UNITED STATES PATENT AND TRADEMARK OFFICE

APPLICATION NO.	FILING DATE	FIRST NAMED INVENTOR	ATTORNEY DOCKET NO.	CONFIRMATION NO.
10/605,943	11/07/2003	Wayne F. Block	GEMS8081.186	2942
27061	7590	11/01/2005	EXAMINER	
ZIOLKOWSKI PATENT SOLUTIONS GROUP, SC (GEMS)			KIKNADZE, IRAKLI	
14135 NORTH CEDARBURG ROAD			ART UNIT	
MEQUON, WI 53097			PAPER NUMBER	
			2882

Office Action Summary	Application No.		Applicant(s)	
	10/605,943		BLOCK ET AL.	
	Examiner		Art Unit	
	Irakli Kiknadze		2882

DETAILED ACTION

FIG 3

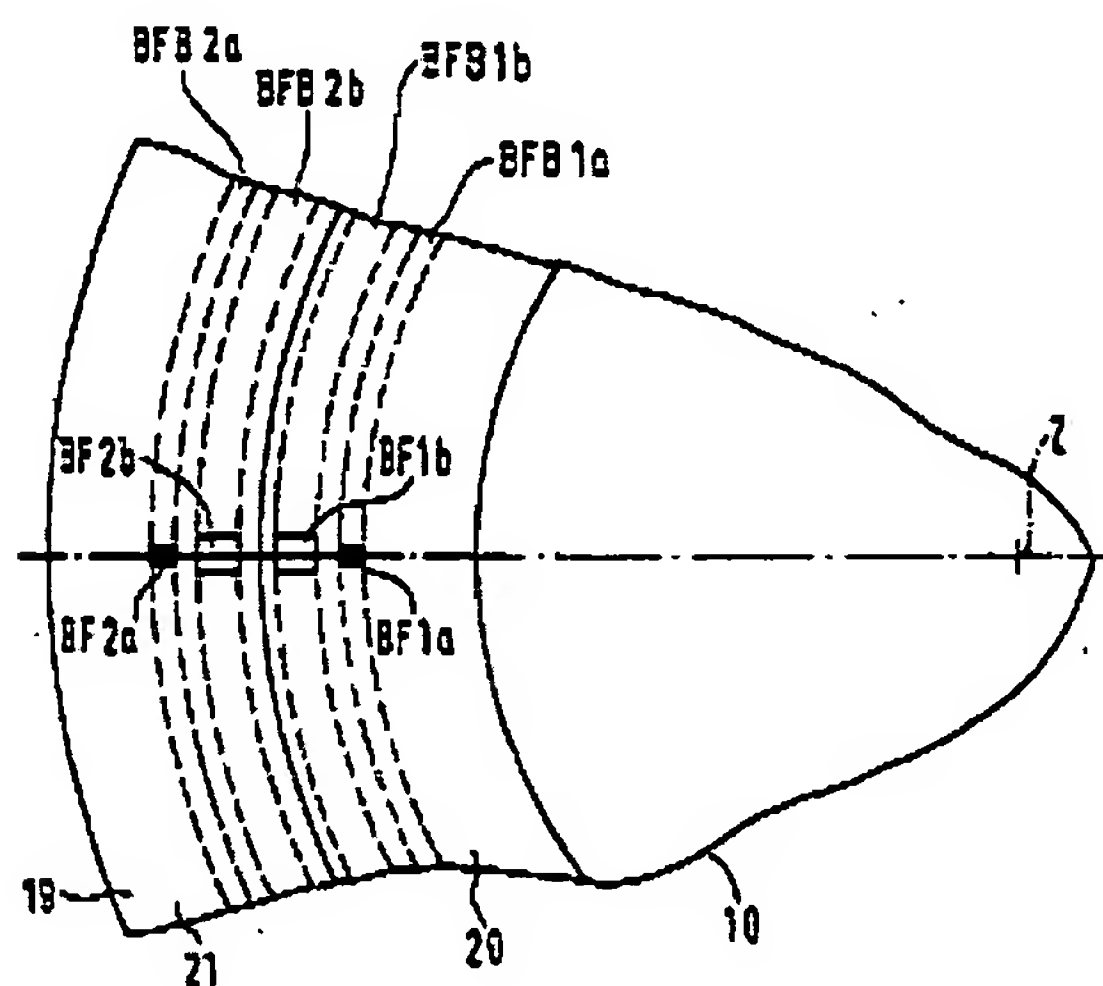
With respect to claim 1, Knott teaches an anode assembly comprising: an anode disc (10); a first x-ray source (BFB1a) connected to the anode disc (10) and configured to emit a first fan beam of x-rays; a second x-ray source (BFB1b) connected to the anode disc and configured to emit a second fan beam of x-rays;

distance from a center of the anode disc (10) different than that of the second x-ray source: and wherein the first x-ray source and the second x-ray source are configured to extend radially about the anode disc (Figs. 1 and 3; column 3, lines 13-41; claim 2).

With respect to claims 3 and 7, Knott teaches that the second fan beam has a spatial coverage equal to that of the first fan beam. The each fan beam have penumbra that extends along a z-axis (Fig.3; see abstract; column 3, line – column 4, line 8).

With respect to claims 11 and 12, Knott teaches that each fan beam extends along a z-axis (Fig.3). A plurality of tungsten targets integrated in a beveled portion of the anode disc (10) (column 3, lines 42-47).
